**Re: Peer Review of Sound Study of Comstock Industrial Park, Cranston, RI**

**Ref: 4770**

**Re: Sound Study of Comstock Industrial Park, Cranston, RI**

Figure 2

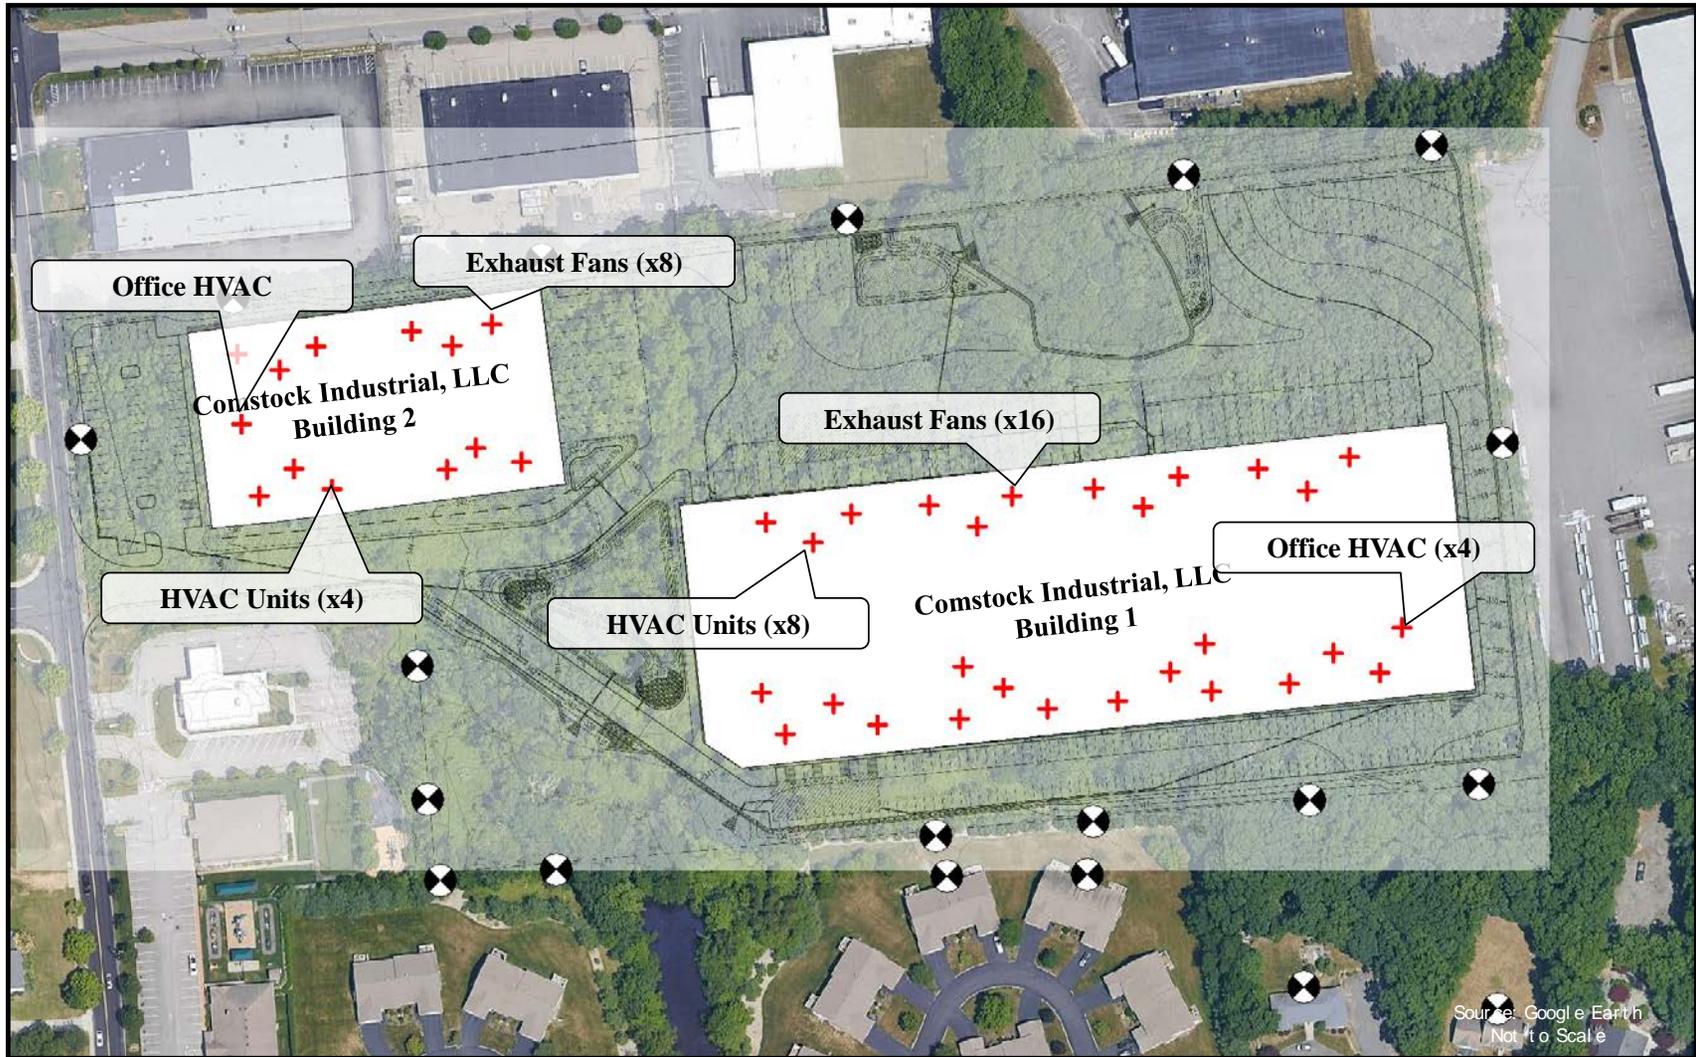
- 1. Mechanical Equipment Assumptions.** Acentech questioned if the Sound Study’s assumptions for rooftop mechanical equipment are accurate and/or are missing equipment, and specifically if the HVAC equipment should include air conditioning condensers and/or chillers, which would be louder than the HVAC equipment assumed in the Sound Study. Furthermore, Acentech questioned if the project includes a backup generator, which is not included in the Sound Study.

Response: The Sound Study appropriately includes (8) warehouse HVAC units and sixteen (16) warehouse exhaust fans on the rooftop of Building 1, and four (4) warehouse HVAC units and eight (8) warehouse exhaust fans on the rooftop of Building 2, as stated in Section 4.2 and is illustrated in Figure 2. The revised Sound Study also includes four (4) office HVAC units on the rooftop of Building 1, and one (1) office HVAC unit on the rooftop of Building 2. These assumptions have been confirmed with the project architect in preparation of this response, and the future mechanical design for the office spaces will likely result in office space mechanical equipment that is quieter than those assumed in the revised Sound Study. This is a conservative approach. The sound power levels assumed for those sources, including octave bands, utilized in the acoustic model are included in Appendix A. The revised Sound Study includes an Appendix B, which includes the manufacturer’s performance data for the rooftop equipment, which includes sound levels that match those in Appendix A and those utilized in the acoustic model. The proposed project is not refrigerated warehouses; thus, the assumptions for rooftop equipment in the Sound Study are accurate, and do not include warehouse air conditioning condensers and/or chillers. Furthermore, the project is not planning for emergency generators, which would be warranted at a production/manufacturing facility or a refrigerated warehouse, which these are not. The proposed non-refrigerated warehouses have no plans for emergency generators, which is consistent with the Project’s site civil plans, which include no foundations for emergency generators.

Figure 4

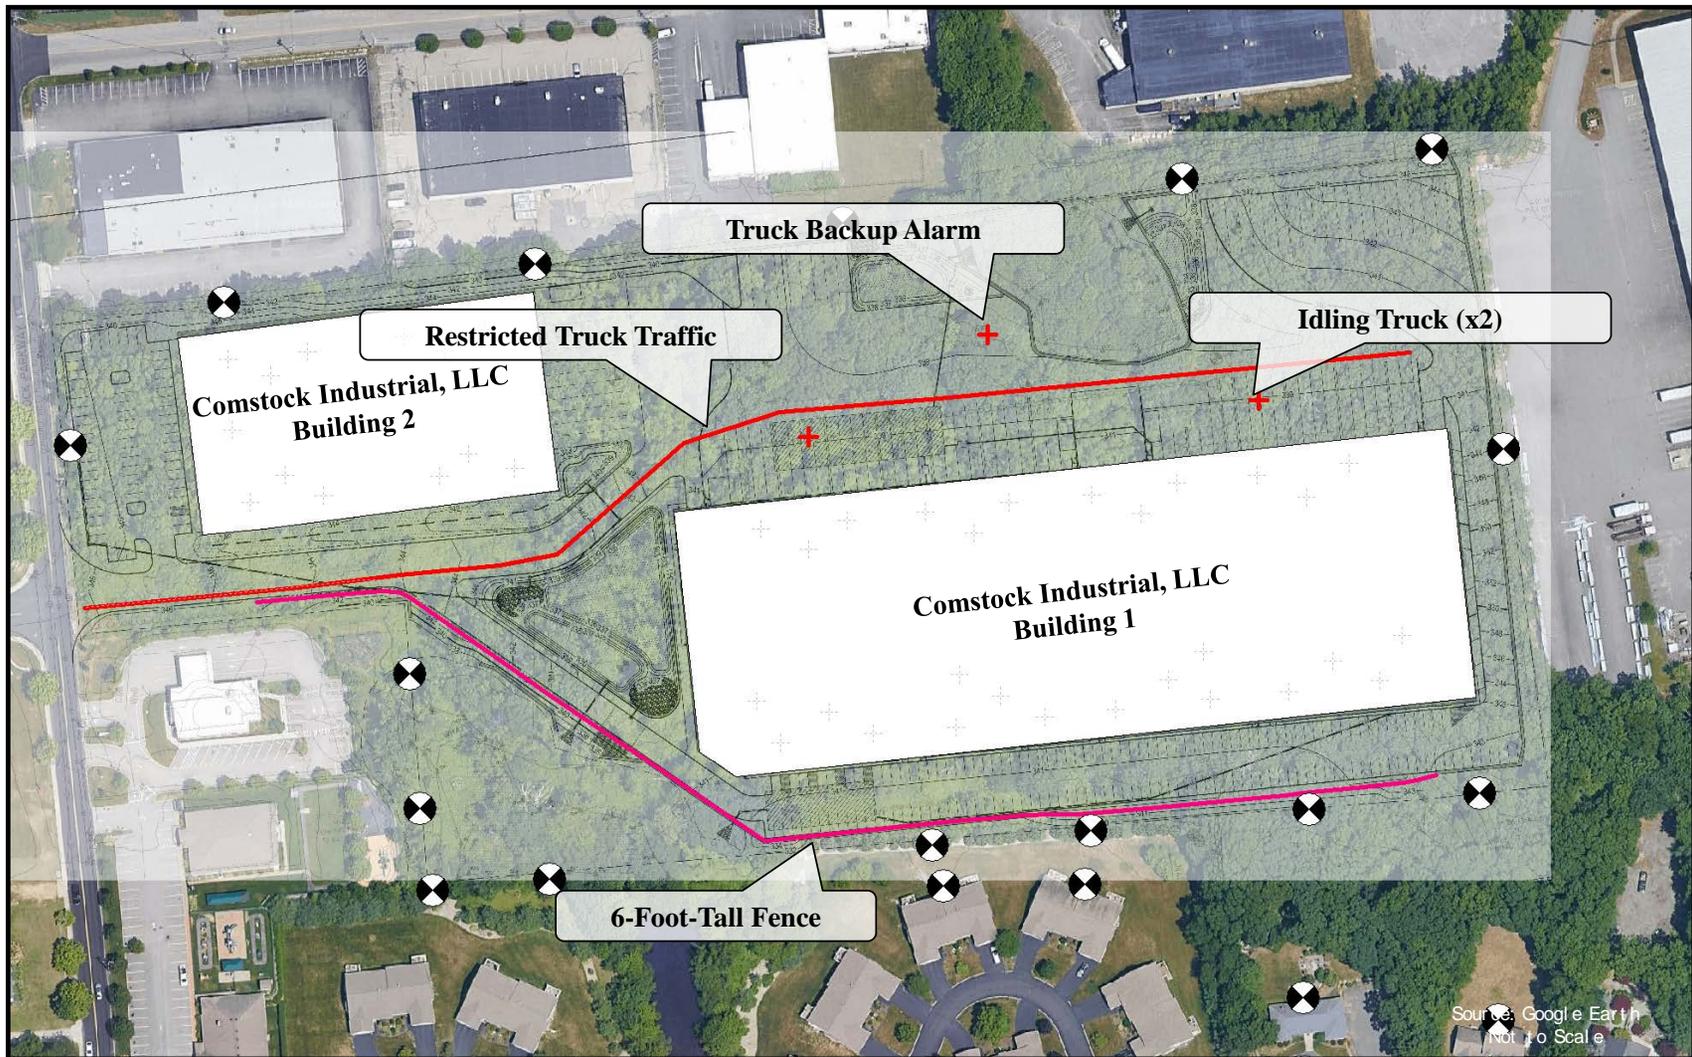
- 4. Truck Operations – Modeling Assumptions.** Acentech commented that truck traffic was modeled as a moving point source with the acoustic modeling software. And Acentech commented that stationary trucks like an idling truck or a truck backup alarm may produce higher sound levels.

- 5. Sound Mitigation.** Acentech commented that the Sound Study did not account for any attenuation by landscaping and/or plantings. Acentech also commented that the proposed solid 6-foot-tall screen wall along most of the southern property boundary should be solid without any gaps and have a minimum surface density of one (1) pound per square foot. Acentech also commented that the receptors along the southern property boundary are located away from the residences and very close to the screen wall. Acentech also commented that sound levels from the project may be higher away from the wall and at the residence and at the elevation of the highest floor.

Response: The revised Sound Study includes two (2) stationary trucks idling and truck backup alarming at the project site.

Response: Tech concurs that the Sound Study did not account for any attenuation by landscaping and/or planting. This is a conservative assumption. The screening wall design is consistent with what has been presented in the landscaping and civil plans for the project. The revised Sound Study includes predicted sound levels at the upper floors of the four (4) residences nearest to the screen wall along the southern property boundary and demonstrates that those impacts are compliant with the applicable limits (see Table 3B, Table 4B, Table 5B and Table 6B).
